Subject: License Amendment Request for LOCA Dose Calculation Methodology and Resolution of Remaining License Condition 2.C.(6) Issues
Cooper Nuclear Station, NRC Docket No. 50-298, DPR-46

PROPOSED LICENSE AMENDMENT FOR
POST-ACCIDENT CONFIGURATION OF
THE MSIV LEAKAGE PATHWAY, PERMANENT
APPROVAL OF LOCA DOSE CALCULATION
METHODOLOGY, AND ELIMINATION OF
LICENSE CONDITION 2.C.(6)

COOPER NUCLEAR STATION
NRC DOCKET NO. 50-298, LICENSE DPR-46

1. Drawing CNS-MS-43, Rev. 1

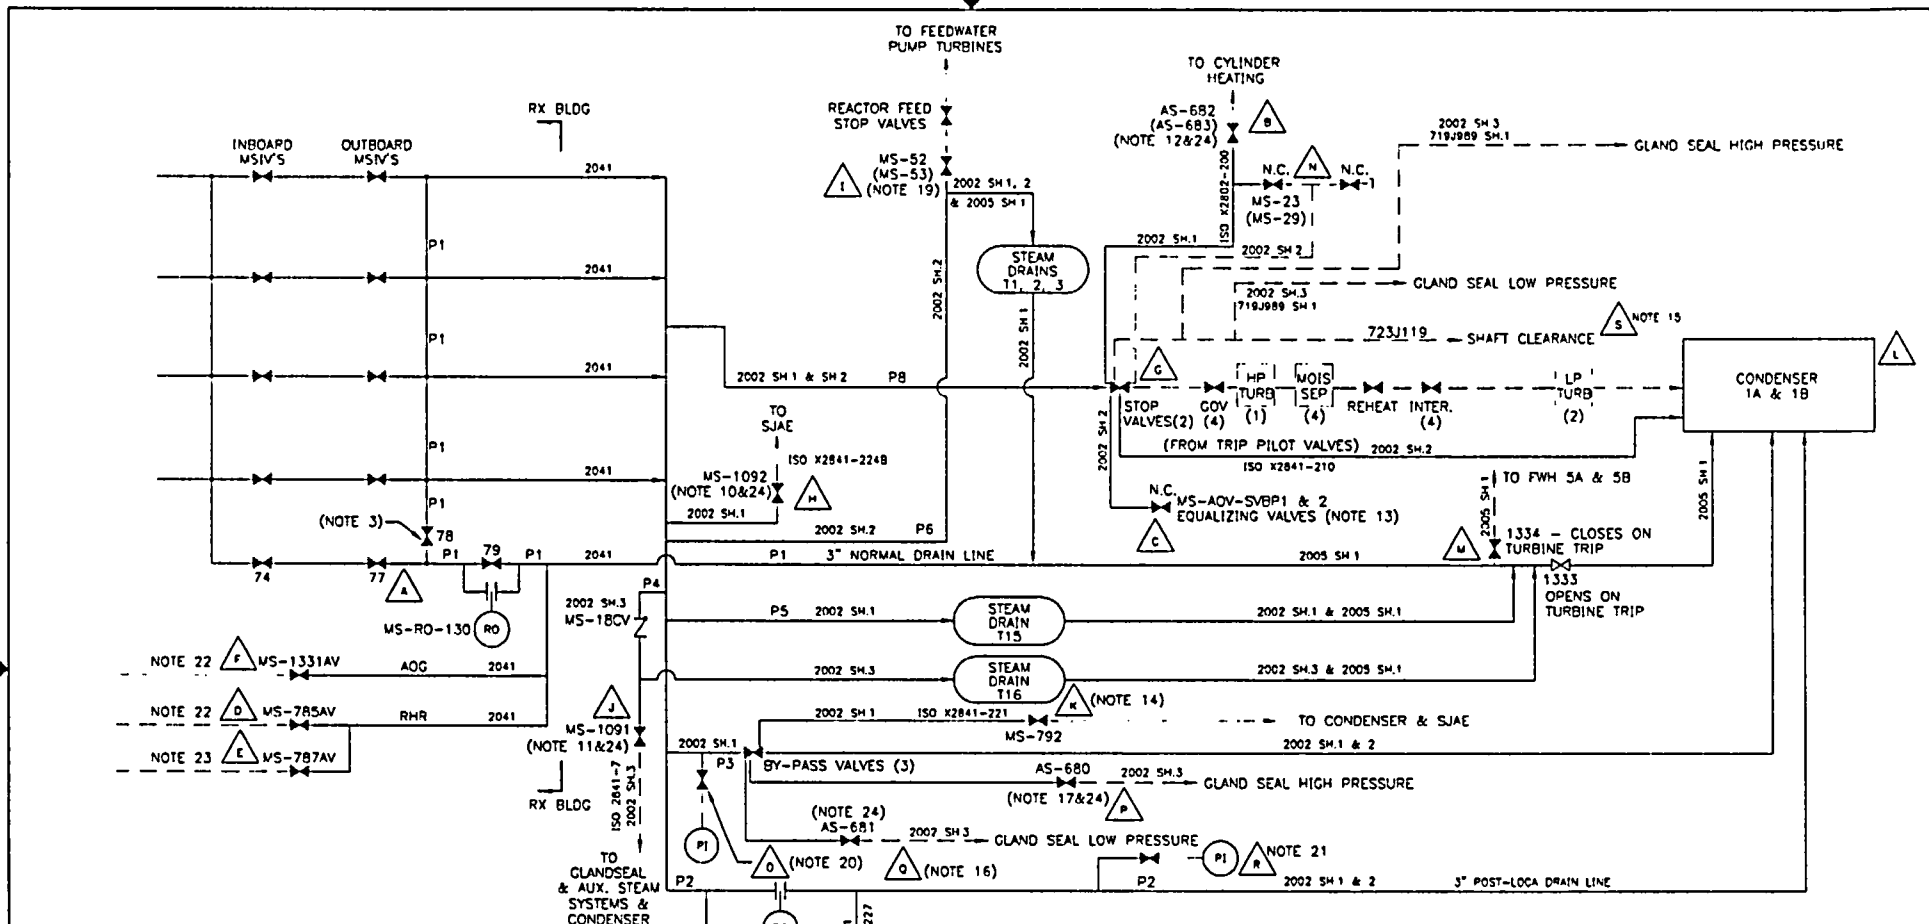
Question 3: *You stated in Reference 1 that "...Five manual isolation valves to be installed on Main Steam branch lines in order to limit the amount of piping to be credited for the MSIV leakage flowpath (and hence, maintained as seismically robust). Post-accident Operator action will be required to close these valves (which will be located in the Turbine Building)..." We request your responses to the following:*

- (a) Explanation as to how those five manual isolation valves will be seismically qualified.*
- (b) Provide a comparison between the CNS MSIV leakage path proposed manual isolation valves and the earthquake experience database concerning seismic performance of this class of equipment.*
- (c) Indicate whether the leakage path with the manual isolation valves installed meets the provisions in the SQUG-GIP 2. If it does not, identify how the outlier conditions were resolved.*

- (d) *Indicate whether the five manual valves will be part of the CNS Inservice Testing (IST) Program. If they are not, provide justification as to why they should not be part of the IST program.*

Response: As shown on Enclosure 1 to Reference 7.5, a total of six new manual boundary isolation valves have been installed in the final design. The latest revision of Drawing CNS-MS-43 is provided as Enclosure 1 to this Attachment for your information. There are 13 valves that are locally closed, two valves that are remotely closed, and three valves that automatically close to isolate the ALT pathway from the unanalyzed piping.

- (a)(b)(c) The 13 locally closed isolation valves range in size from ¾" to 5". These valves do not belong to any of the designated SQUG-GIP 2 valve classes of equipment (i.e., Fluid Operated Valves, Motor Operated Valves, or Solenoid Operated Valves). In the application of the SQUG-GIP 2, manual valves are classified as "Inherently Rugged Equipment," and as such, do not require their seismic adequacy to be verified in the USI A-46 program (see Section 3.3.5 of Reference 7.6).

Accordingly, no outlier conditions existed as result of the use of these boundary valves. The valves were considered in the overall evaluation of the piping systems by the methods previously submitted for NRC review (see Reference 7.7, Enclosure 1, Section 4.5.4.4). In Section 4.5.4.4, NPPD provided a summary of results for piping and pipe supports that also included a description of the "Correlation with the Piping Experience Data". The same methodology was applied to the piping systems on which the new and existing valves are configured.

- (d) NPPD does not propose to add the ALT pathway boundary valves to the Inservice Testing (IST) Program. Since these valves are not classified as ASME Section XI Class 1, 2, or 3 it is unnecessary to include them within the 10CFR50.55(f) IST Program. Moreover, NPPD's understanding of the NRC Safety Evaluation of NEDC-31858P-A is that only motor-operated valves that are remote-manually opened to establish the pathway are candidate for inclusion in the IST Program (see Reference 7.3, Volume 1 Tab 1 Section 5.3, and Tab 5 NRC Concern #12). Nonetheless, the manual valves that are either: a) closed to configure the boundaries of the ALT pathway, or b) opened to establish a flowpath to the Main Turbine Condenser, will be cycled during each Refueling Outage to assure their functionality. NPPD will describe this testing in the Updated Safety Analysis Report (USAR), with future changes being reviewed in accordance with 10CFR50.59, and reported with the USAR update per 10CFR50.71(e).

GENERAL ARRANGEMENT
 TURBINE BUILDING
 OPERATING FLOOR PLAN

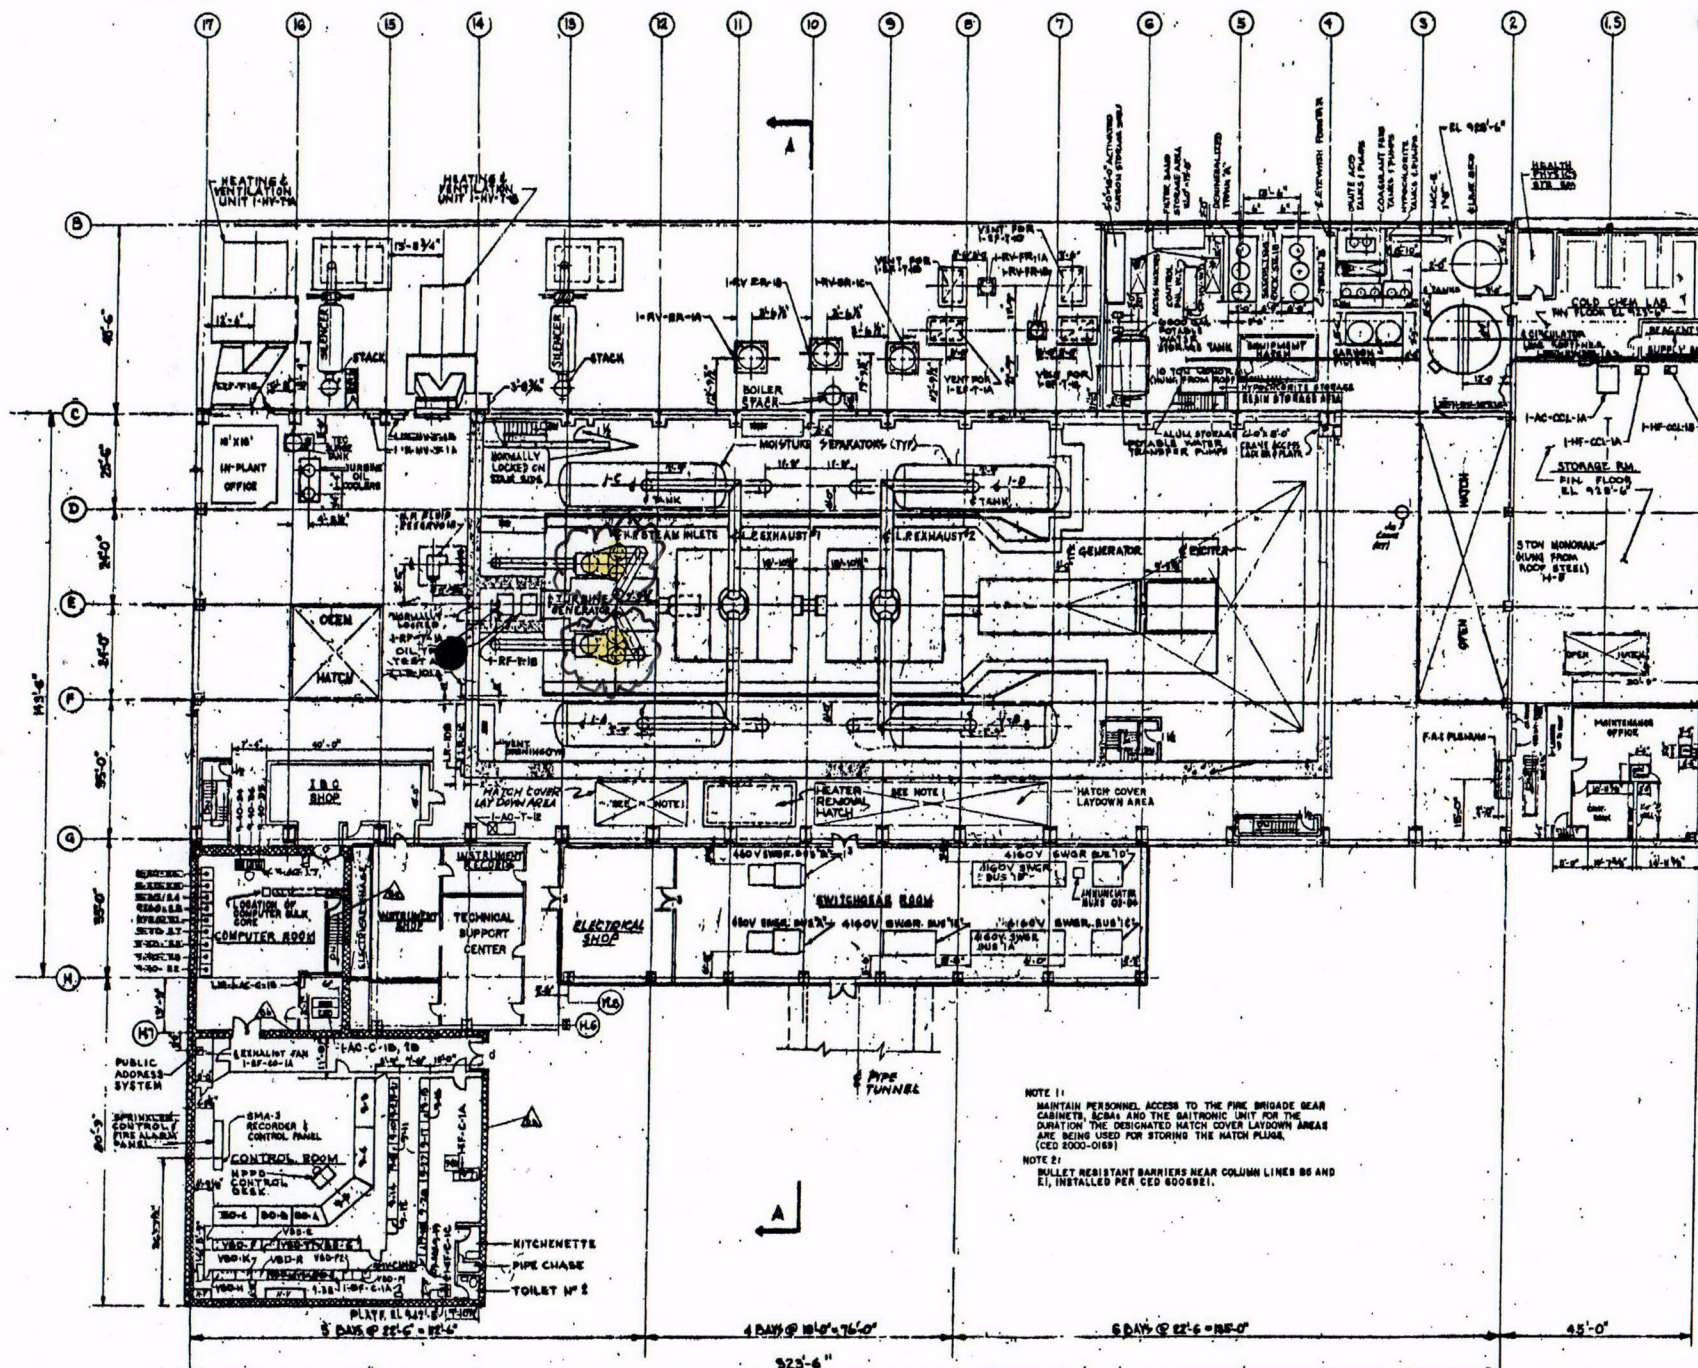
Question 4: *You stated in Reference 3 that "...The cross-sectional leakage area is being reduced by mechanically adjusting the Stop Valve actuator/control shaft positions through use of a special pre-staged tool, applied as a post-Loss of Coolant Accident manual action..." The NRC staff requests responses to the following:*

- (a) *Explanation as to how the mechanically adjusted Stop Valve actuator/control shaft with a special pre-staged tool will be seismically robust.*
- (b) *Provide a comparison between the MSIV leakage path Stop Valve actuator with the proposed adjustment and the earthquake experience database concerning seismic performance of the equipment class that encompasses the reconfigured Stop Valve.*

There are two Turbine Stop Valves at CNS that are upstream of the one high pressure turbine. The Turbine Stop Valves are located on the Turbine Building operating floor (elevation 932'-6"; 29 feet above grade elevation 903'-6") (refer to Enclosure 2, Drawing 2052 for general arrangement). The SQUG-GIP criteria for the Fluid Operated Valves equipment class were used to evaluate the Turbine Stop Valves, with no outliers being identified. The post-LOCA installation of the shaft sealing tool has negligible effect on the Turbine Stop Valve evaluation. The structurally simple and seismically robust tool is manually threaded into the pre-threaded end of the 5 inch diameter Turbine Stop Valve shaft and torqued to a specified value of 100 ft-lb (refer to Enclosure 2, Sketch SKE-CED6007261-30). The weight of each tool is approximately 25 pounds which is insignificant compared to the weight of the large Turbine Stop Valve. The tool creates a very small and negligible eccentric load on the valve. In the event of a postulated SSE, the tool will remain intact and perform its sealing function because its threaded fastener (bolt) component is preloaded to several thousand pounds of force which is more than adequate for preventing the tool from becoming loosened during a postulated SSE. In addition, under normal and SSE loading conditions, the tool will not induce any loading that could adversely affect the Turbine Stop Valve.

- (c) Part 8 The pre-staged tools consist of one shaft sealing tool for each Turbine Stop Valve shaft and a calibrated torque wrench for tightening the shaft sealing tool to a specific torque value. These items are located in a metal box on the outside of the Turbine Building operating floor concrete shield wall but near the Turbine Stop Valves (refer to Enclosure 2, Drawing 2052). There are no other special tools required to perform this task.

ENGINEERING SKETCH	PREPARER DLR	DATE 9/24/02	 Nebraska Public Power District
TURBINE STOP VALVE ACTUATOR SHAFT TOOL COOPER NUCLEAR STATION	INDEPENDENT VERIFICATION	DATE	
SHEET 1 OF 3		SKETCH NUMBER SKE-CED6007261-30	REV 0

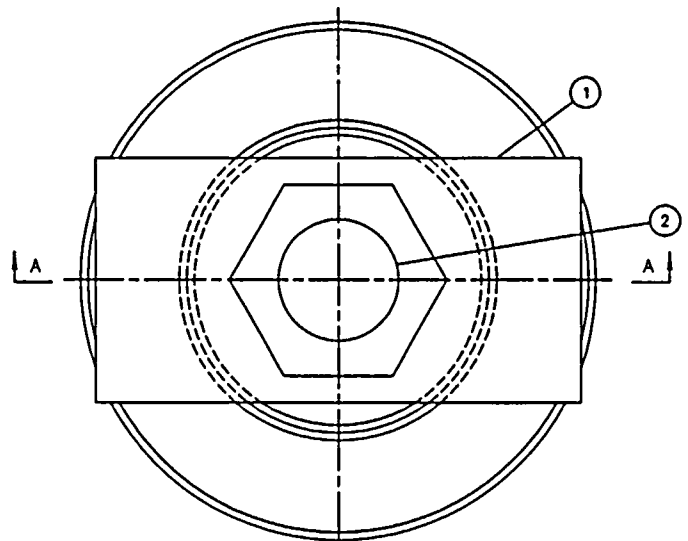
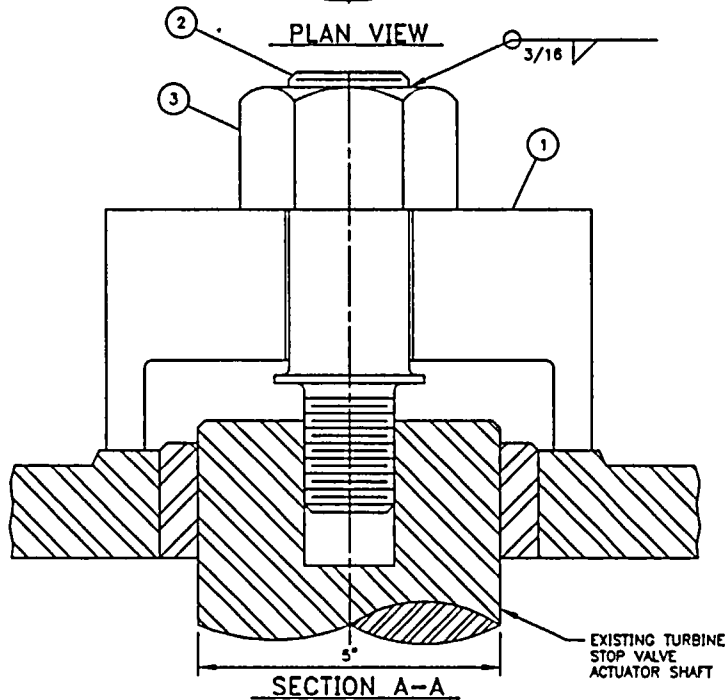
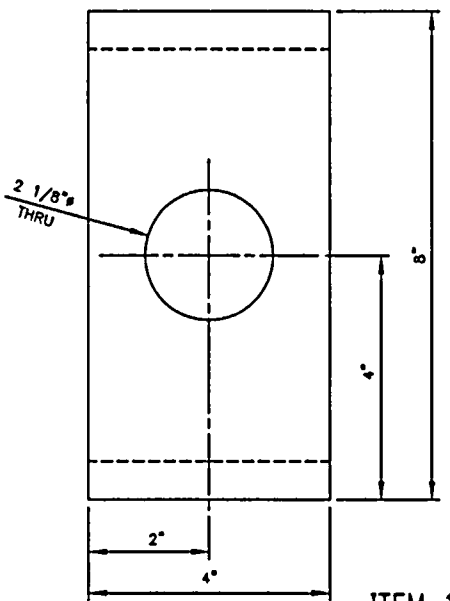
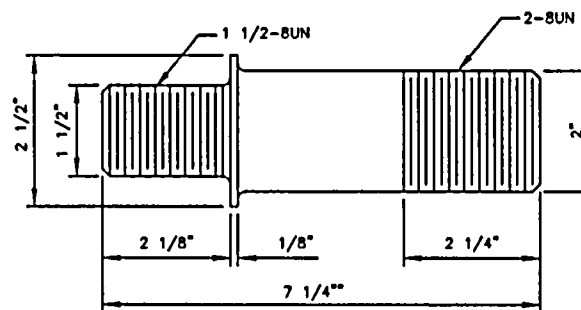
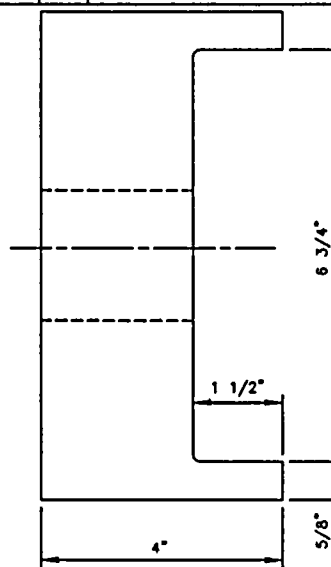
- (c) *Explain how the post-Loss of Coolant Accident (post-LOCA) manual action is accomplished. Supplemental information, such as diagrams/photos/illustration of the prestaged tool, Stop Valve actuator, location of task to be performed, etc., will be beneficial to include in the response. At a minimum, the following questions should be addressed in the explanation:*

- 1. *What step(s) is/are involved in performing the actions(s), i.e., how much physical and mental effort does the task require? How many Stop Valves will require manual adjustment? If more than one valve is involved, where are the valves located in relation to one another?*

- 7. *What is the pre-staged tool?*

In order to address this issue, CNS has constructed and pre-staged two (2) shaft sealing tools. Each tool is fabricated to the materials and dimensions shown on Enclosure 2, SKE-CED6007261-30. When required by the implementing CNS emergency procedure, these shaft sealing tools are manually installed on the two Turbine Stop Valve shafts. The shaft sealing tools are located near the Turbine Stop Valves (between approximately 25-35 feet away) in a metal box (reference Enclosure 2 Drawing 2052). Since each tool weighs approximately 25 pounds, it can be handled and installed by a single person.

One end of each Turbine Stop Valve shaft has an internally threaded hole. The shaft sealing tools consist of a threaded fastener component that goes through an oversized hole in a steel squared "U" shaped bracket. The shaft tool is manually threaded into the shaft end until the bracket contacts the outside of the valve housing. (refer to Enclosure 2, Attachment 1 to Procedure 5.2FUEL, and attached photos).

Elimination of the clearance area is accomplished by torquing the threaded fastener component to 100 ft-lb. This forces the shaft seal ring against the valve bushing. This torque will create a force on the shaft that is more than twice the force needed to seal the clearance area and is well below the maximum allowable design torque of the tool's threaded fastener component. The shaft needs to move less than 1/10 of an inch to provide an effective seal. The 100 ft-lb torque is accomplished with a pre-staged calibrated torque wrench that is included in the metal box along with the shaft sealing tools near the Turbine Stop Valves.

Figure 2 - Main Steam Stop Valve

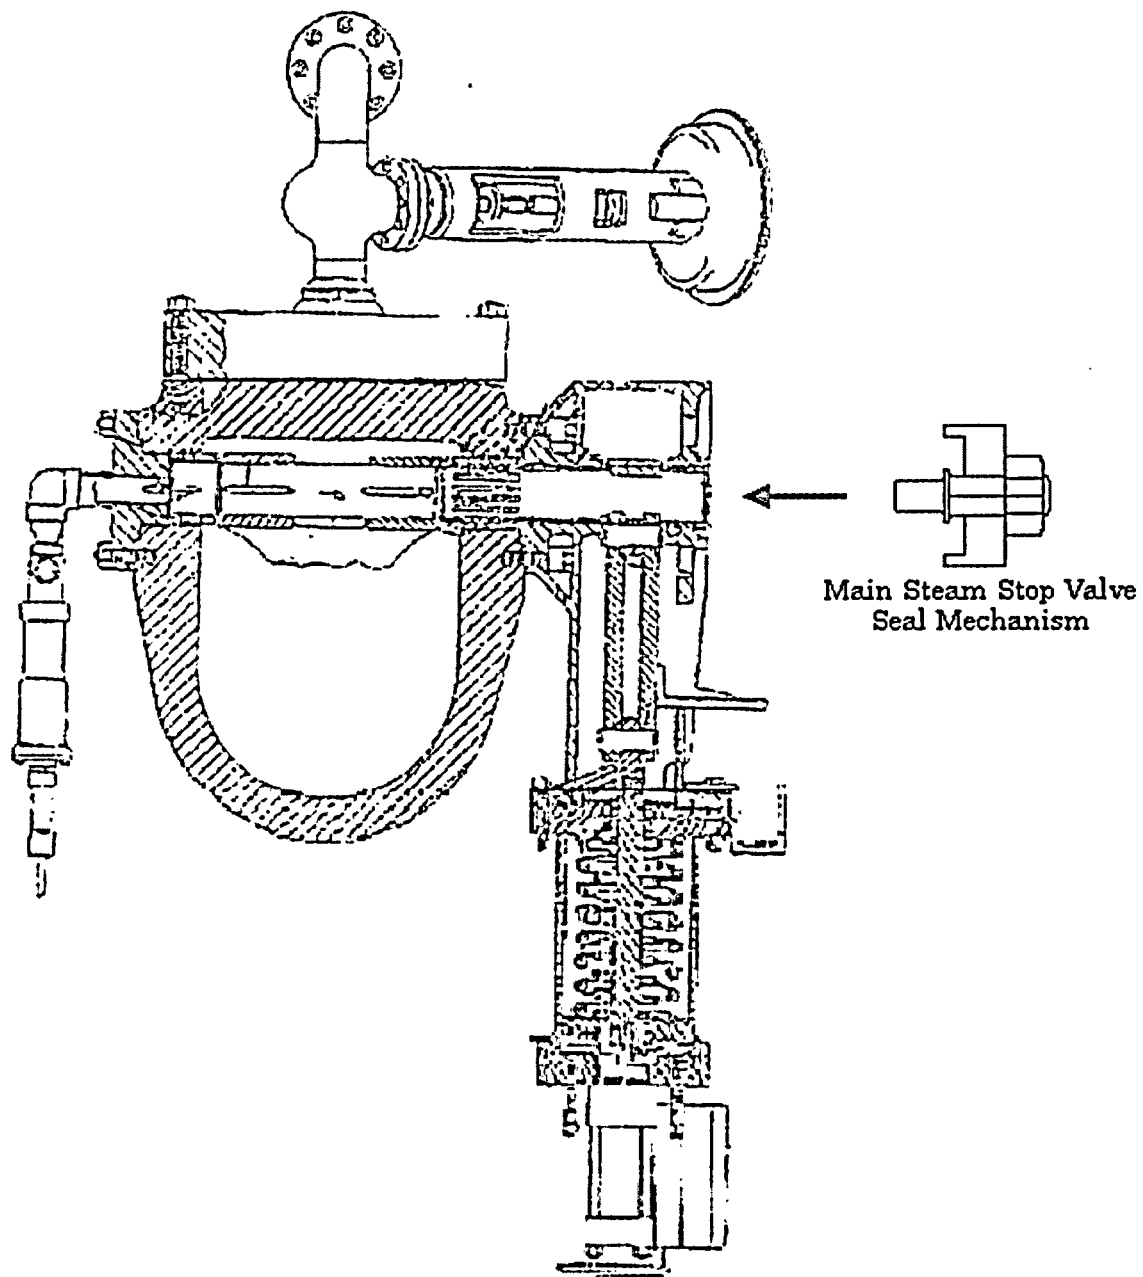
Question 2: *With respect to the turnbuckle device, explain what role/purpose the device serves and why it is needed relative to the guidance specified in NEDC-31858P, Rev. 2, and confirm that the fraction of MSIV leakage to the high pressure turbine (i.e., ratio of flow areas satisfies the criteria specified in Appendix C of NEDC-31858P, Rev. 2.)*

Response: The purpose of the Turbine Stop Valve shaft adjustment tool (turnbuckle device) is to eliminate potential direct leakage from the ALT pathway to the Turbine Building via the two Turbine Stop Valve shafts. This leakage could occur assuming a loss of gland seal steam. A shaft adjustment tool is installed on each Turbine Stop Valve shaft (two total) to close the clearance by moving the shaft outwards from the valve body such that a shaft sealing ring (located on the inside of the valve body) is sealed against the face of the valve bushing. Sealing in this manner (shaft sealing ring to valve bushing) is the sealing method that occurs during normal operation, except that steam itself provides motive force instead of a shaft adjustment tool.

Since the leakage pathway of concern is directly to the Turbine Building rather than the High Pressure Turbine, the Appendix C fractional leakage equation is not explicitly applicable. However, it is understood that the intent of that methodology is to limit MSIV leakage to the Turbine Building that does not egress from the Main Turbine Condenser, where iodine plateout is most effective. Application of the shaft adjustment tool will isolate the leakage boundary at the Turbine Stop Valve shafts. This action, in concert with the isolation of the other boundary valves, will assure that the MSIV leakage will reach the Main Turbine Condenser via a seismically rugged pathway.
